**JOINT REGIONAL PLANNING PANEL
(Sydney East Region)**

JRPP No	2012SYE089
DA Number	LDA2012/0314
Local Government Area	City of Ryde
Proposed Development	Construction of a residential tower (known as Building E) and landscaping works.
Street Address	126 Herring Road, Macquarie Park
Applicant/Owner	Toga Macquarie Developments Pty Ltd
Number of Submissions	1
Recommendation	Approval with Conditions
Report by	Sandra Bailey, Team Leader Major Development

Assessment Report and Recommendation

Figure 7. Basement floor plan showing the approved concept plan outlined in red.

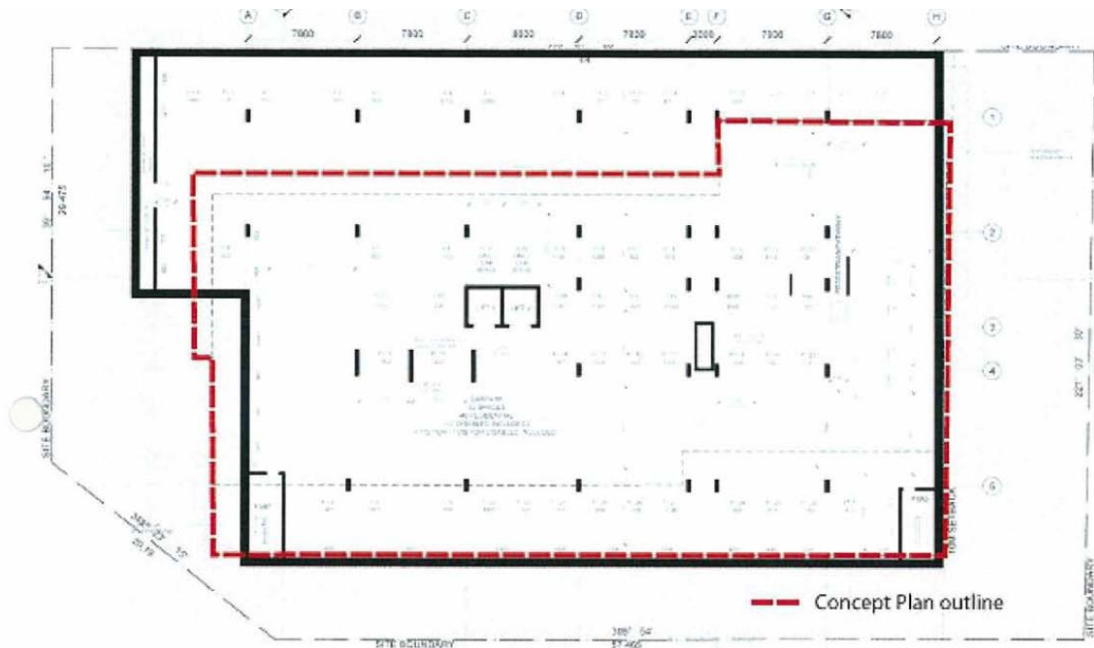
The car park wall dominates the ground floor of the building on all sides with the exception of 2/3 length along the new street elevation. The proposed car park footprint exceeds the concept plan envelope. This additional car park footprint may be acceptable if the benefits to the streetscape in accordance with Council DCP are demonstrated and the Panel's comments below are addressed:

Comment: The following plan shows the location of the approved car parking footprint of the Concept Plan and the proposed basement level plan. The car park extends beyond the approved concept plan in the vicinity of the new road. The car park in this area is below natural ground level.

This breach does not result in any adverse impacts to the streetscape. Accordingly, the breach is considered acceptable.

Figure 12. The above figure demonstrates how acoustic privacy will be maintained between apartments 1.02 (and above) and 1.03 (and above).

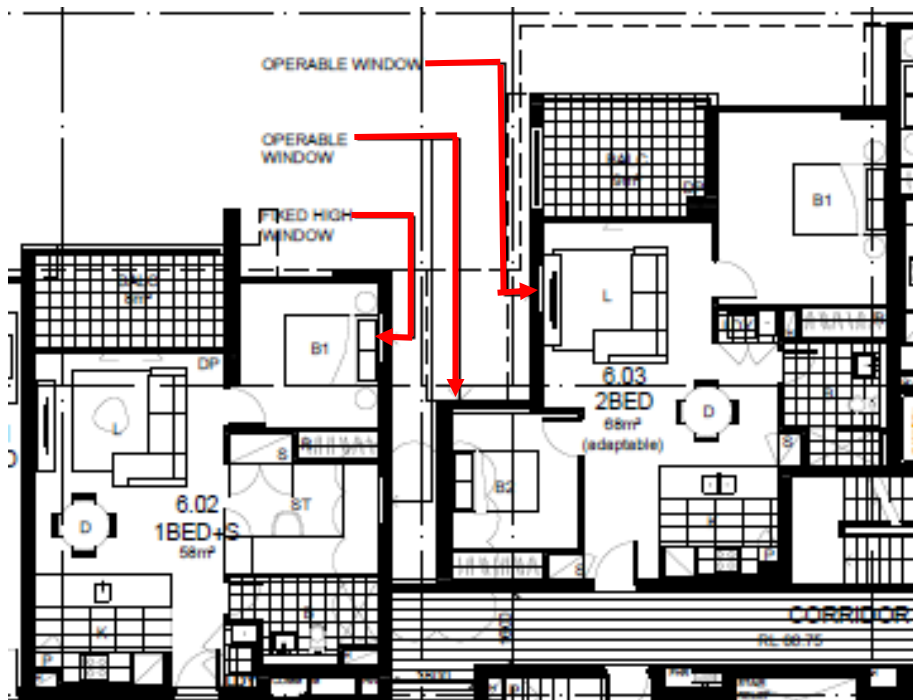
Acoustic privacy between units may be compromised. The Panel recommends that the high level window to Unit 1.02 (and above) be deleted.

Comment: The applicant has amended the plans that the bedroom window to unit 102 (and above) will be a fixed window. This will ensure acceptable acoustic privacy between units 1.02 and 1.03. This is demonstrated in the following figure. A report has been provided from Cundall to demonstrate that this change will not affect the cross ventilation in the unit.

Figure 13. Typical layout of apartments containing a study.

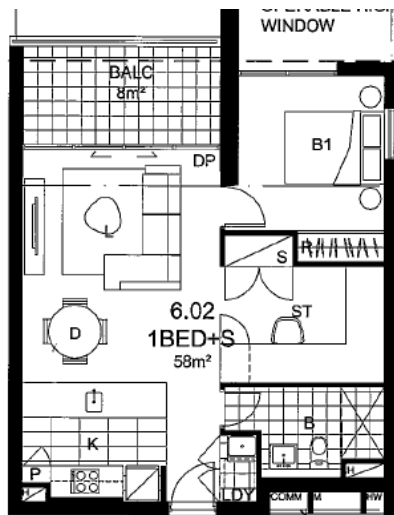
The Panel does not support inboard rooms that could become bedrooms without a window, for example the ‘studies’ shown in units 1.02 and 1.11. The market demand for student accommodation with study space does not preclude an alternative market for student share housing, where these types of spaces would become bedrooms. The Panel recommends these spaces be deleted (preferred) or minimized by locating the desk/joinery along the long wall to limit their conversion and/or rotating bathrooms to provide a longer narrow study space adjacent to the dining space.

Comment: The applicant has further amended the plans to provide the joinery and cupboard space. A typical layout is demonstrated on the following plan.

This combined with a condition of consent to restrict the use of the study areas as bedrooms is considered adequate in addressing the Panel’s concern. (See condition No. 71).
